Corrective Action Decision Document
for Corrective Action Unit 423:
Building 03-60 Underground
Discharge Point, Tonopah Test Range,
Nevada

Appendix D - Response to NDEP Comments

NEVADA ENVIRONMENTAL RESTORATION PROJECT
DOCUMENT REVIEW SHEET
 (Page 1 of 1)

Figure A.2-2
Configuration of Building 03-60 UDP and Drilling Strategy

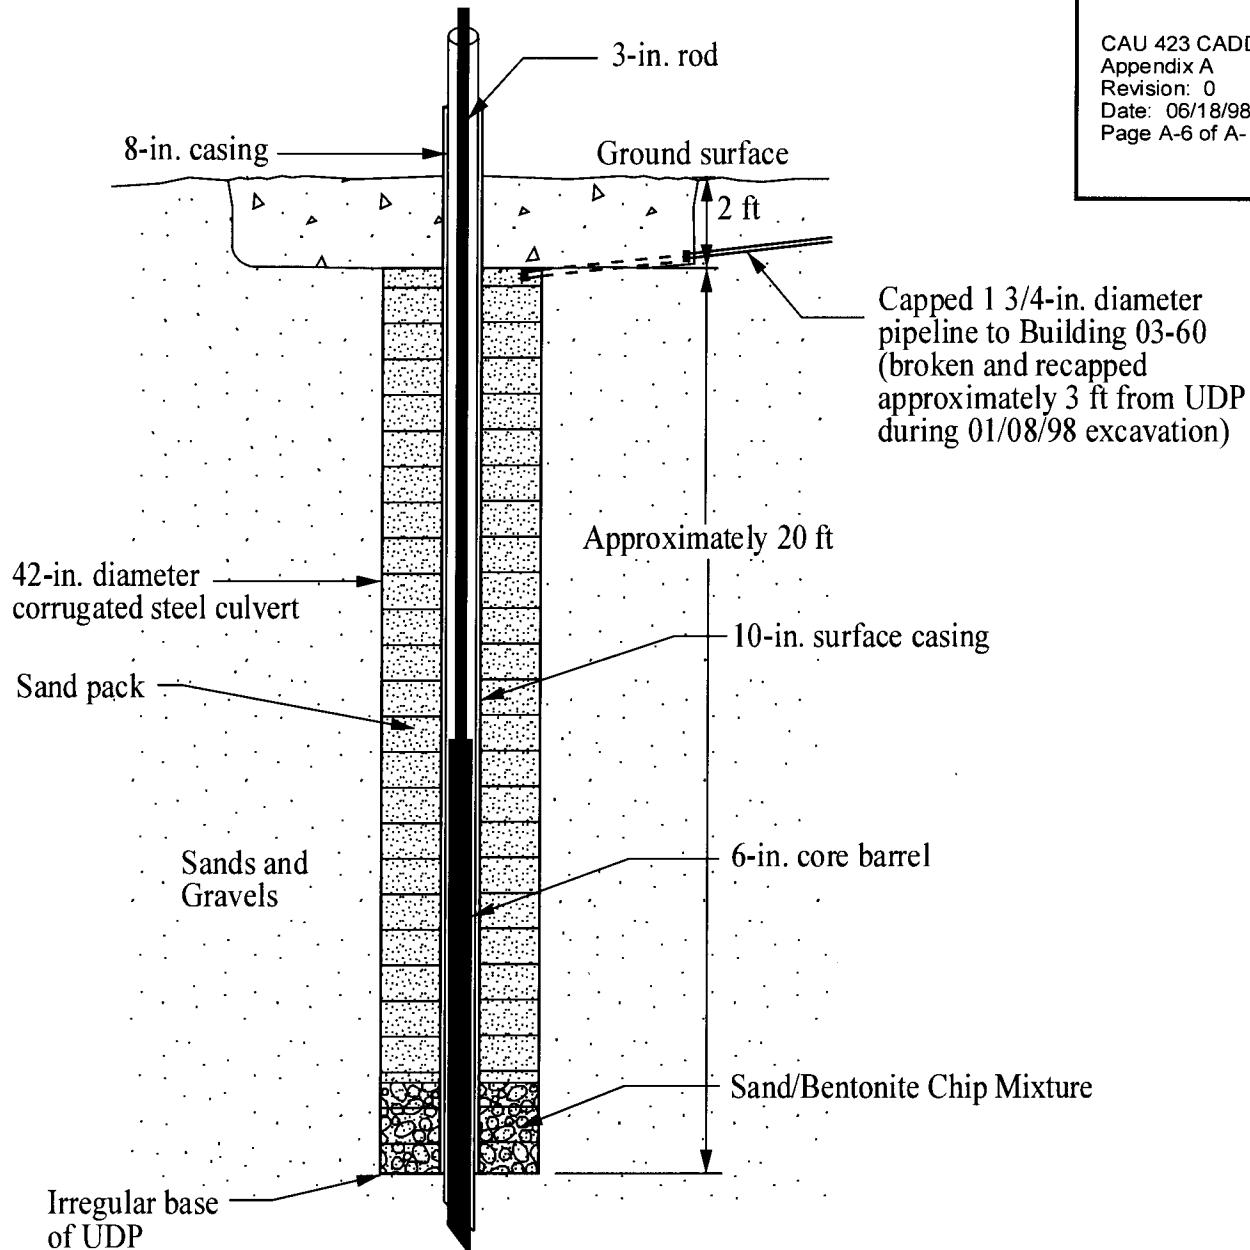
4	M	On page 16, reference is made to a casing that was installed to allow drilling through the center of the UDP. How many of these were installed? What boring sample was taken from this location and what are the dimensions of the casing?	The first sentence was replaced with the following: "A 25-cm (10-in.) surface casing was installed to allow drilling of boring B1 through the center of the UDP (Figure A.2-2). This surface casing was left open pending corrective action decisions and will have to be addressed by either cutting the casing below ground surface and filling with a grout material or removing and grouting the hole."
